Permit Number: 070627

**City of Portland, Maine - Building or Use Permit Application**

July 17, 2007

GLICKMAN COTTAGE  
GREAT DIAMOND ISLAND  
PORTLAND, MAINE

1 CROSS SECTION  
1/4" = 1'-0"

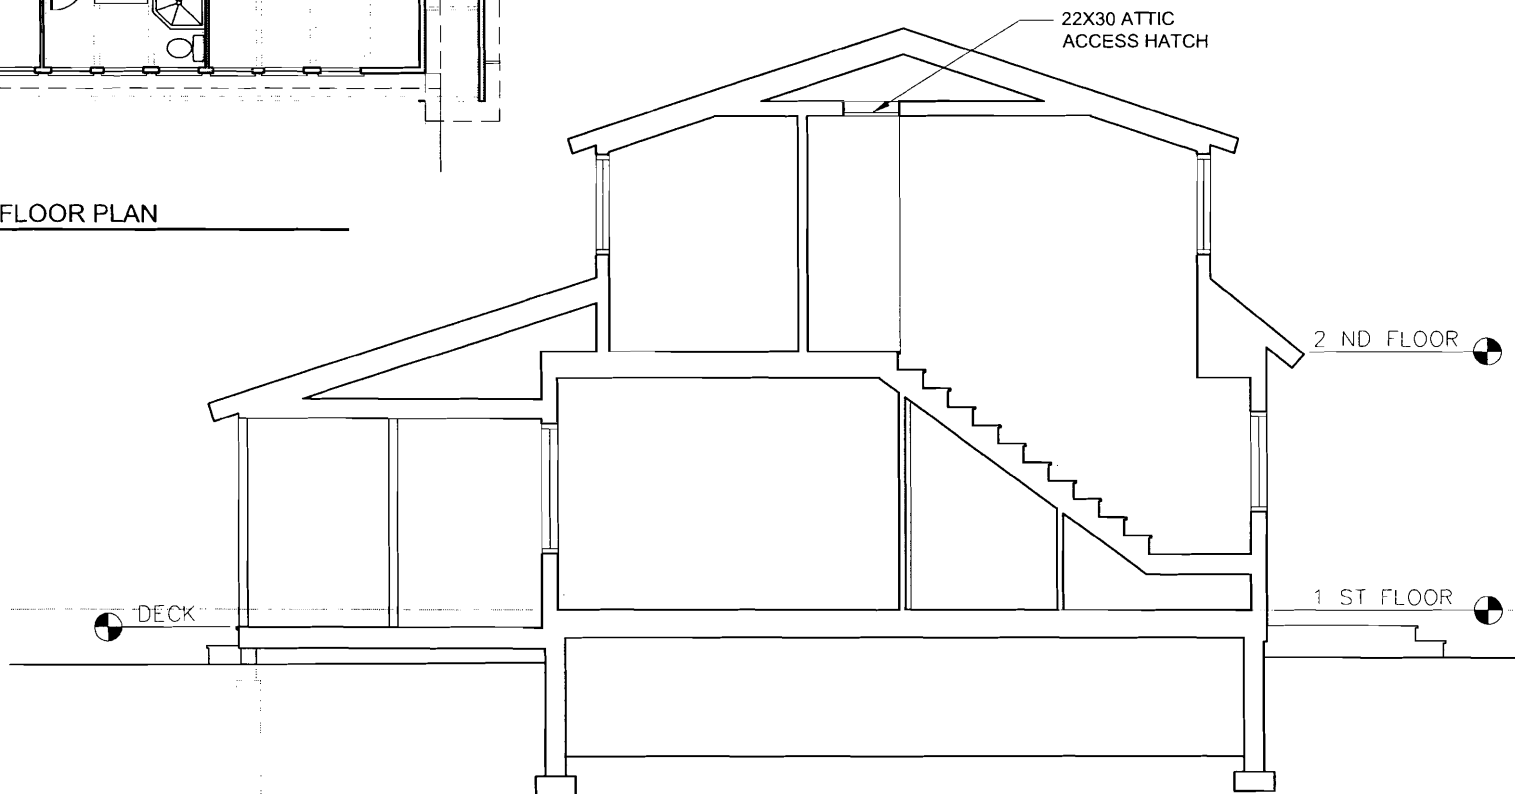
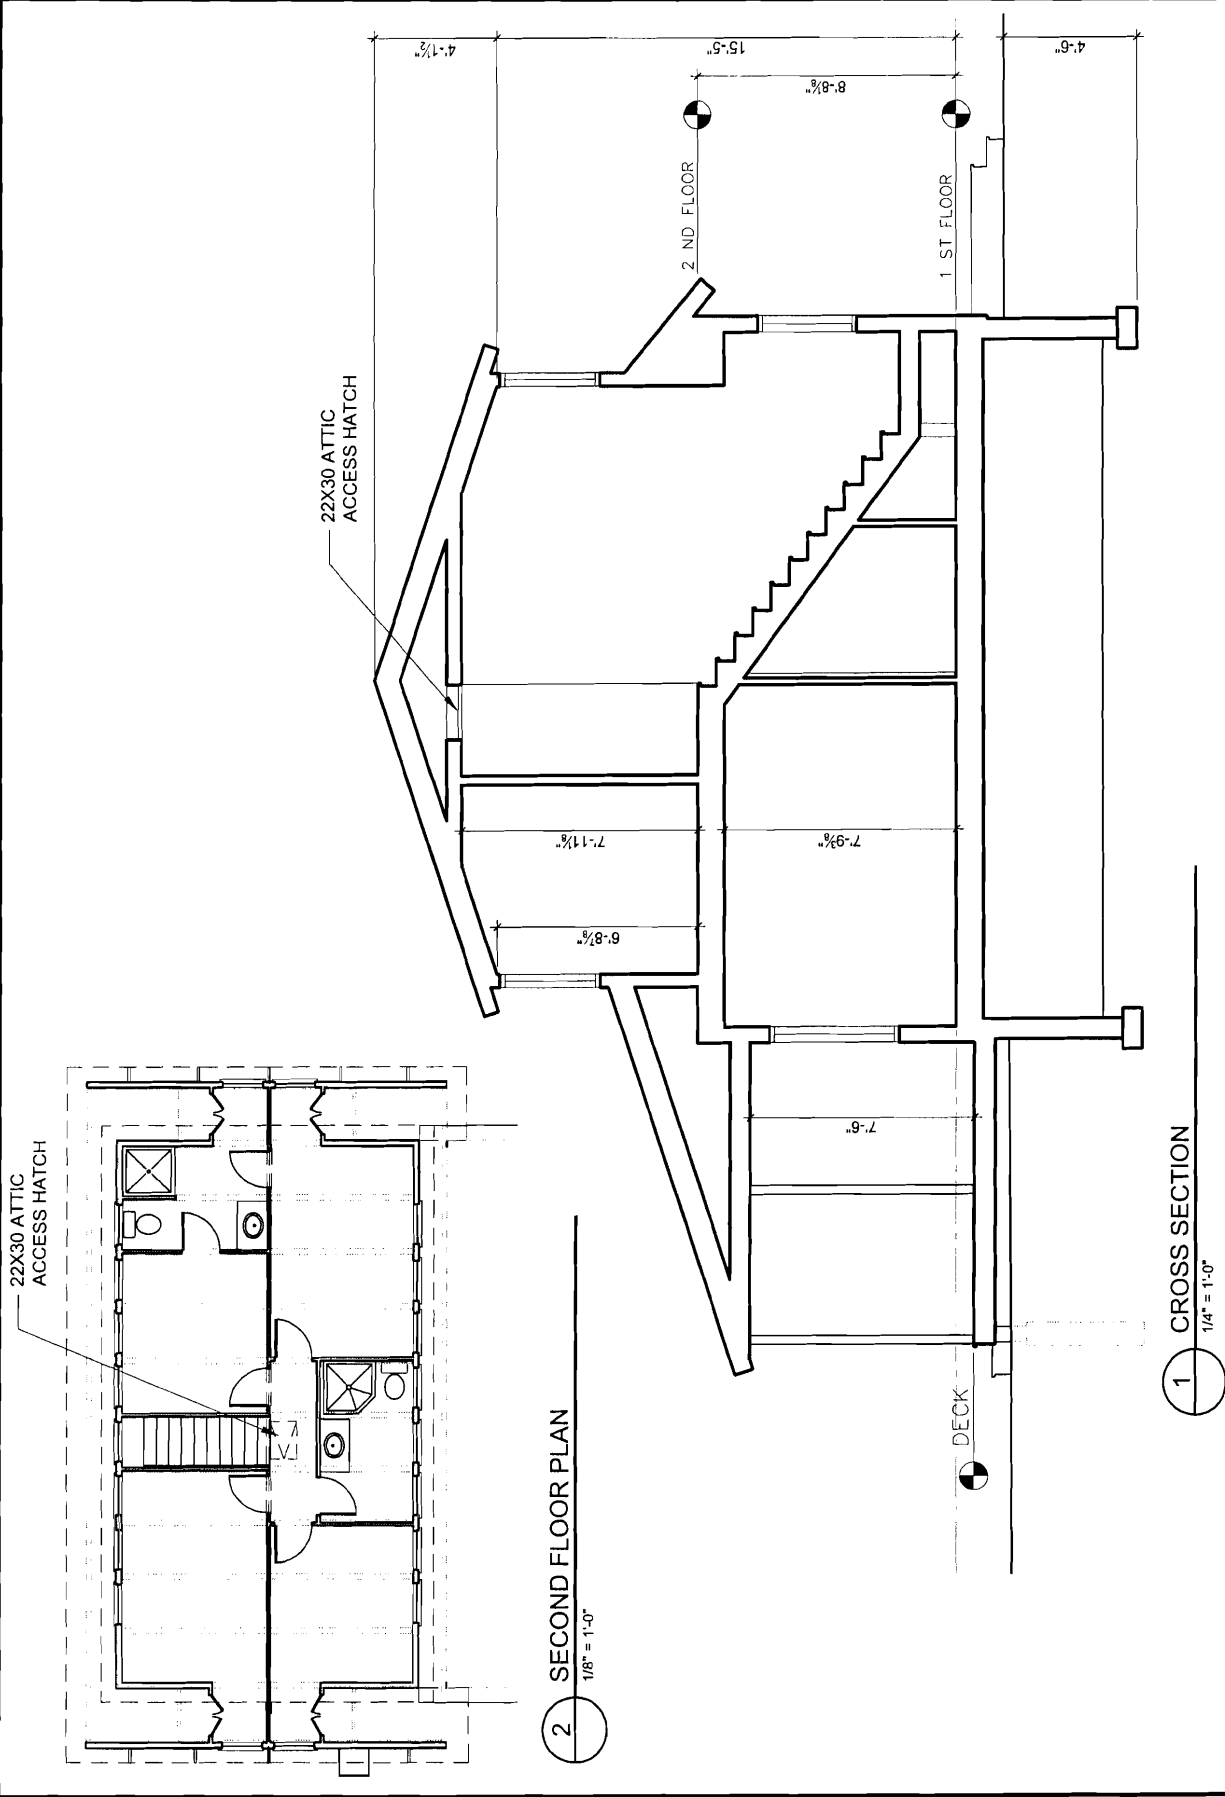
- 1) The attic scuttle opening must be 22" x 30".
- 2) As discussed, all bedrooms must have one egress window.
- 3) A copy of the enclosed chimney or fireplace disclosure must be submitted to this office upon completion of the permitted work or for the Certificate of Occupancy.
- 4) The design load spec sheets for any engineered beam(s) must be submitted to this office.
- 5) Separate permits are required for any electrical, plumbing, or HVAC systems. Separate plans may need to be submitted for approval as a part of this process.
- 6) Hardwired interconnected battery backup smoke detectors shall be installed in all bedrooms, protecting the bedrooms, and on every level.

want full cross section

- 2.) Attic access – see the attached Cross section and plan indicating attic access.
- 3.) The insulation values are as follows: R-20 exterior walls, R-32 roof, R-32 floor above crawl space.
